Subject: Review of Wastewater Management and Related Groundwater Hydrology

24/01861/FUL Erection of a country house and gardens, stables courtyard, new highway accesses, solar array, drainage works and landscape proposals, including a new lake

Figure 1 Solid Geology of Upper Dorn, SSSI and Development Site**Figure 2 Geological Cross-Section of the Upper Dorn**

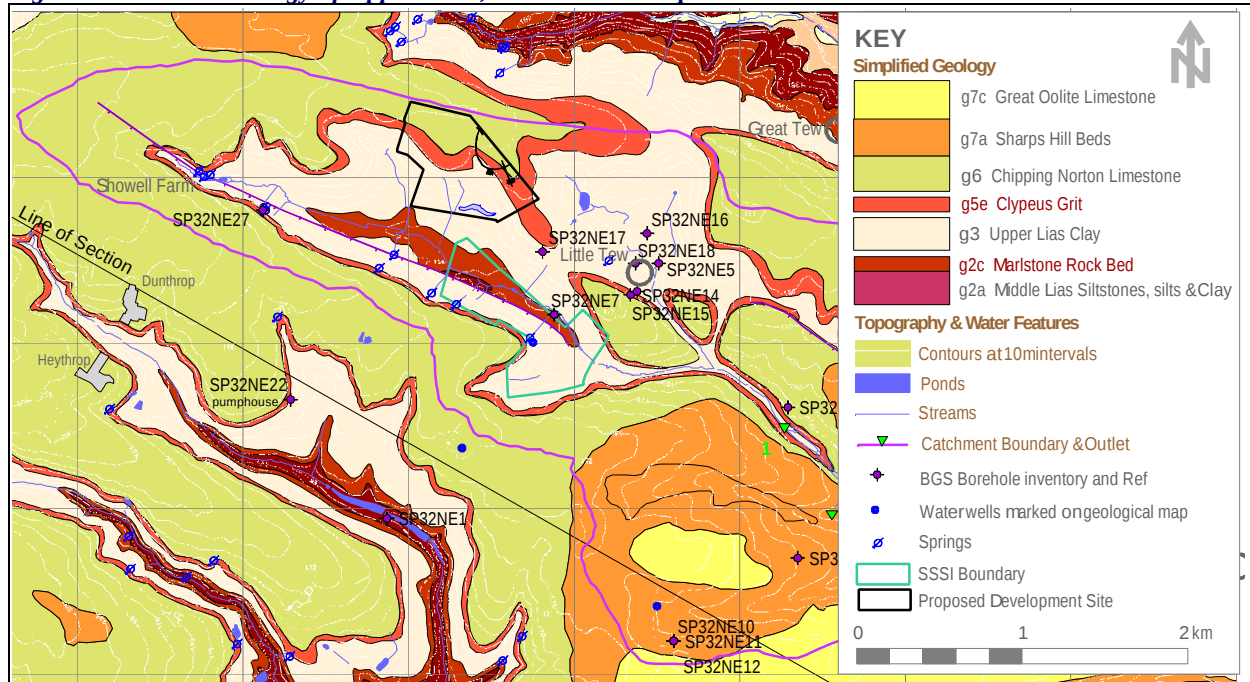
Although the Price & Myers Hydrological Assessment report dismisses the area of proposed buildings as “being located on impermeable Whitby Mudstone” [Upper Lias Clay], the stable buildings would in fact be located on Clypeus Grit and the main house close to the boundary of Clypeus Grit and Whitby Mudstone. There may therefore be better opportunities to investigate use of infiltration to manage surface water runoff by infiltrating into the Clypeus Grit and/or upper horizons of the Whitby Mudstone. The position of buildings is shown in [Figure 1](#).

Figure 3 Springs at Little Tew fed from Clypeus Grit / Upper Part of Whitby Mudstone

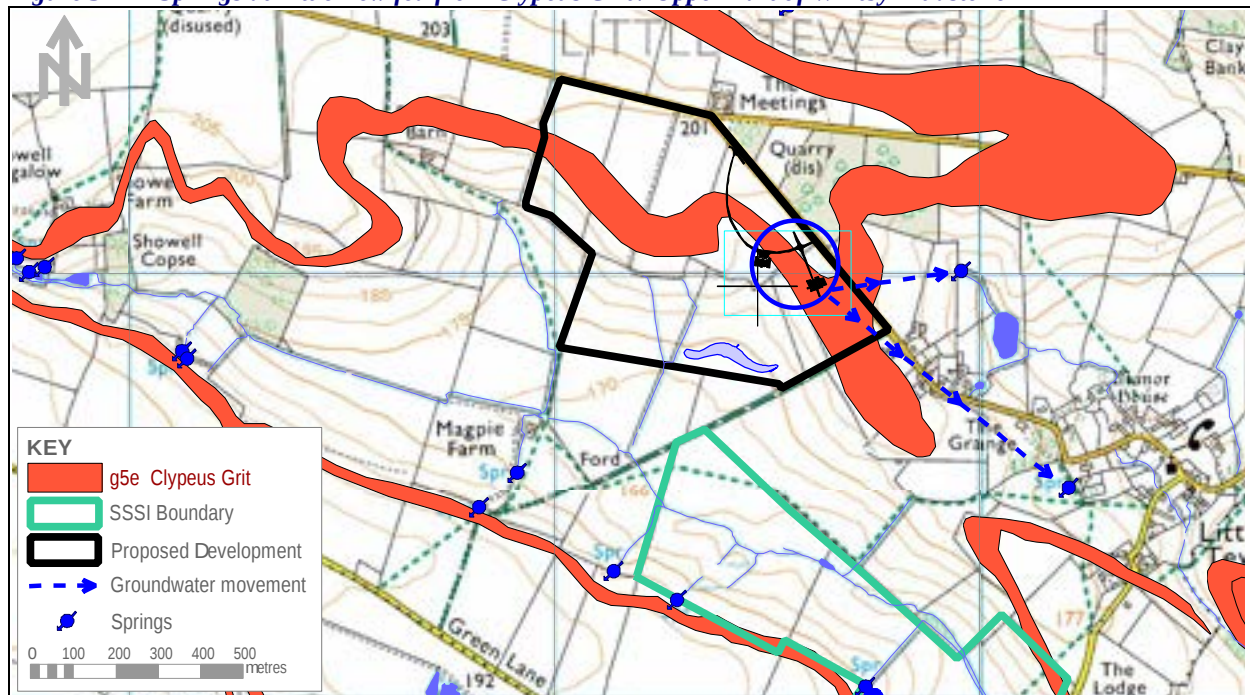
This sentence demonstrates a lack of understanding of the local geology, and the whole document is keen to dismiss contentious issues with microscopic sketches of proposed outline design. A project of this scale should have a robust ground investigation, which would provide data that can be used to demonstrate feasibility and design of drainage and wastewater systems. [Figure 3](#) shows the positions of the project buildings relative to the Clypeus Grit and upper part of the Whitby Mudstone which are water-bearing formations and feed local springs.

Figure 4 *Proposed Drainage and Wastewater System Layout*

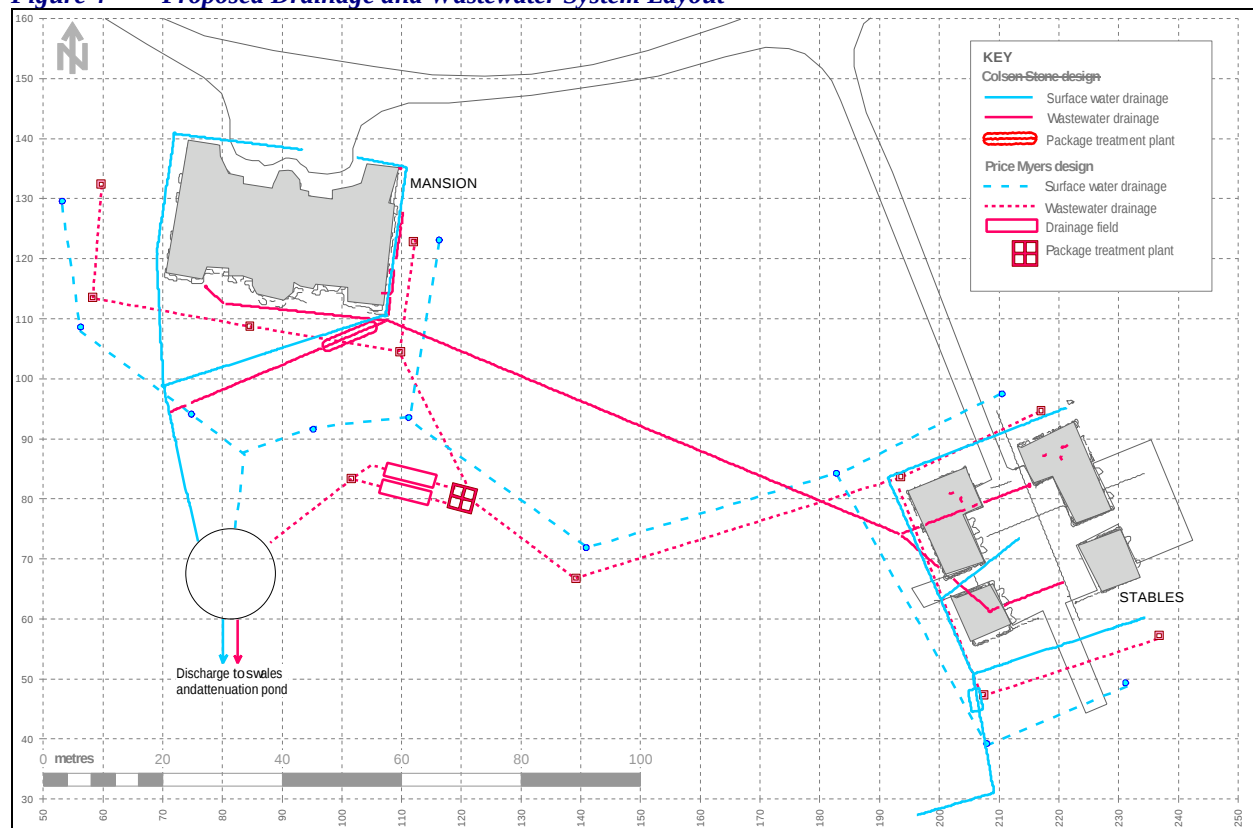
There would appear to have been at least three consultants involved in the project design, and the most recent documents refer to conflicting drainage and wastewater designs by Colson Stone and Price Myers. The two different layouts are shown in [Figure 4](#). Both show package treatment systems and the Price Myers design shows a drainage field with overflow to the surface water attenuation pond.

Drainage fields are never designed to have overflows: they are instead intended to provide tertiary treatment by allowing treated effluent to infiltrate through the unsaturated part of an underlying aquifer, known as the vadose zone. This infiltration in aerobic conditions allows final improvement of a wastewater prior to entering local groundwater. Drainage fields should be designed to British Standard BS6297:2007+A1:2008: no design details are shown in the Price Myers report.

Design of drainage fields [also known as infiltration basins] requires data on the sub-soil and rate of infiltration, obtained through ground investigation and testing [not carried out by Price Myers].

It is surprising that this form of treatment has been indicated, given the earlier incorrect comment by Price Myers that the site is located on impermeable mudstone substrate.

Consideration has not been given in the Price Myers design to the increased nutrient loading of effluent from the stables block.

Both surface water drainage and treated wastewater effluent would terminate in the proposed attenuation pond at the bottom of the property. Given that the only inflow to this pond is periodic rainfall-generated runoff, in contrast to the continuous inflow of wastewater effluent, the pond will become eutrophic during summer months, which will likely have an impact on ecological aspects of the adjacent SSSI [classified as 'unfavourable recovering'].

Given the ephemeral nature of runoff input, the pond is unlikely to dilute the effluent during summer months before discharging into the local ditch and then the River Dorn.
